## ADDENDUM NUMBER 2

### CITY OF JOHNSON CITY FOUNDERS PARK

**TO: ALL INTERESTED PARTIES CONCERNING THE BID DOCUMENTS FOR THE CITY OF JOHNSON CITY – FOUNDERS PARK**

## STANDARD CURB & GUTTER SECTION

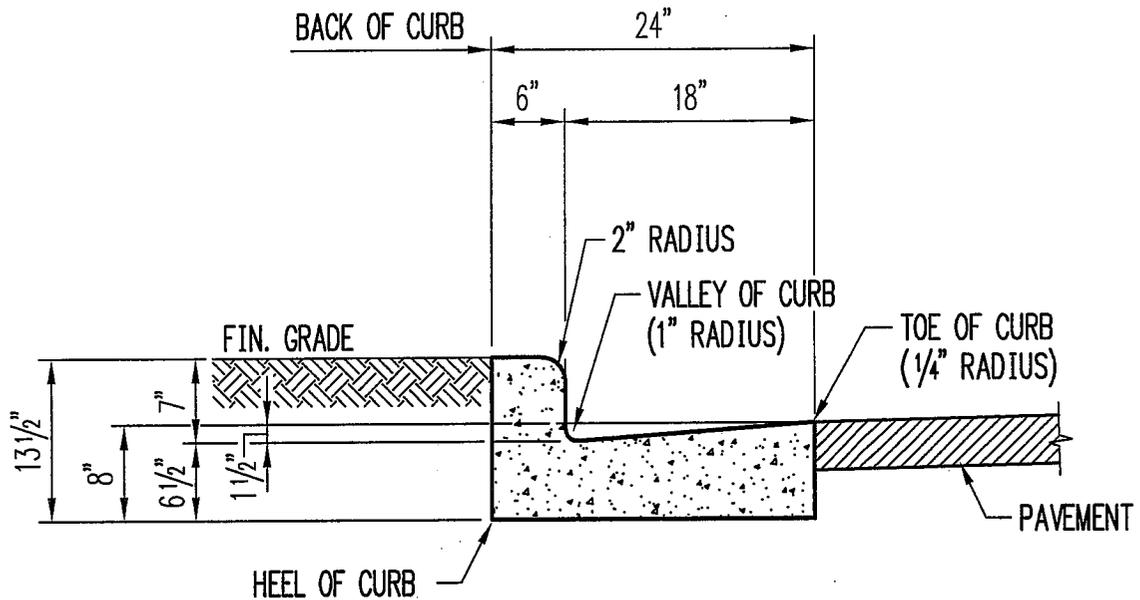
- Q. Is the Contractor responsible for the rubble that remains from the building demolition?
- A. Yes.
- Q. Where is the detail for the curb and gutter?

- A. See attached.
- Q. The drawings show sanitary sewer manholes to be removed. Is the piping to also be removed?
- A. Any sanitary sewer manhole to be removed will be done by others.
